PIC18F27/47/57Q83 Silicon Errata and Data Sheet Clarifications

PIC18F27/47/57Q83

1.6.1. UART TXDE Signal May Go Low Before the STOP Bit Has Been Entirely Transmitted

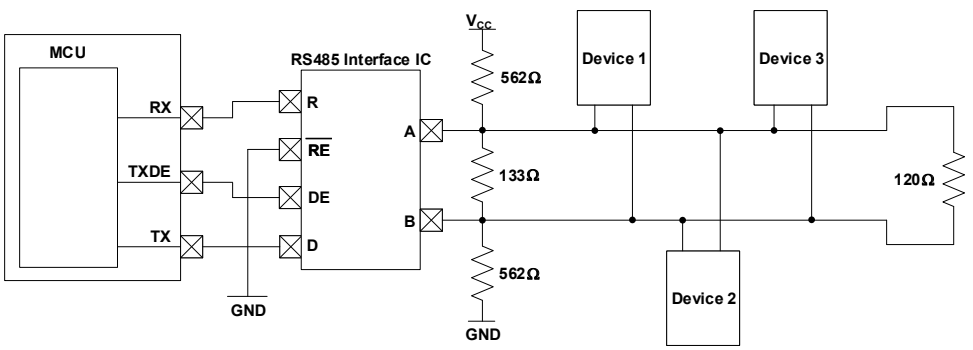
The UART Transmit Drive Enable (TXDE) signal could potentially transition into a low state before the UART Stop bit has been entirely transmitted due to the effects of parasitic capacitance on the TX line. In some applications, this could result in communication being prematurely terminated due to the TXDE signal going low before the STOP bit has had enough time to settle.

To ensure that the Stop bit settles into its final logic state before the TXDE signal transitions low, a biasing circuit can be implemented. A biasing circuit allows the TX line to either be driven high or low, rather than being left in a floating tri-state mode, where prolonged rise or fall times could lead to communication being disrupted. This bias circuit must only be implemented on one end of the serial bus, and a termination resistor must be used on the other end. The figure below shows an example of a bias circuit that can be used to achieve this.

Please note that the resistor values used in this circuit are recommendations and that the actual resistor values required may vary based on the application.

48-Lead Plastic Thin Quad Flatpack (Y8X) - 7x7x1.0 mm Body [TQFP]

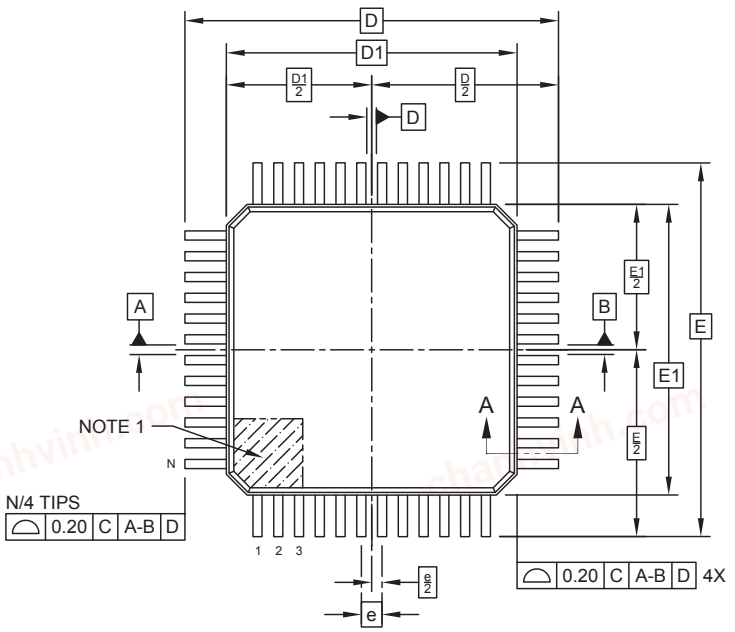
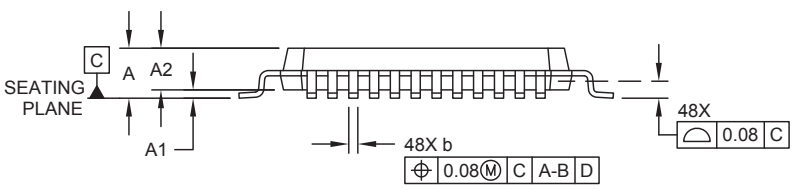
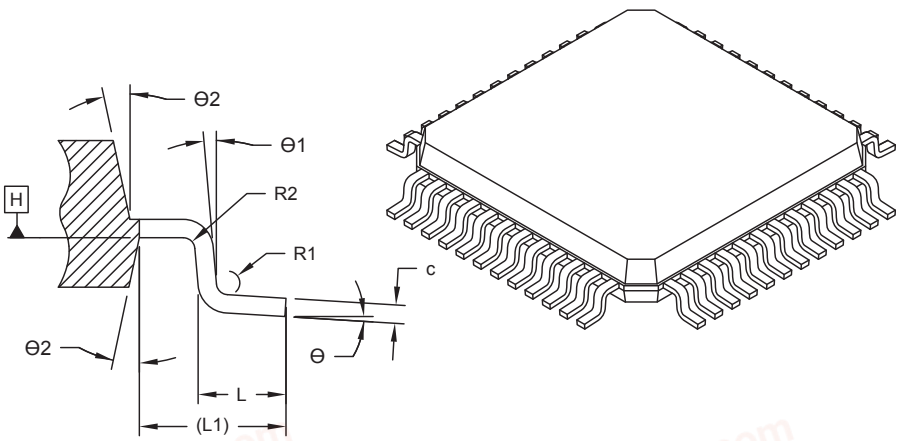
The data sheet lists the incorrect package drawing for the 48-lead TQFP package. The correct package drawings are shown below:
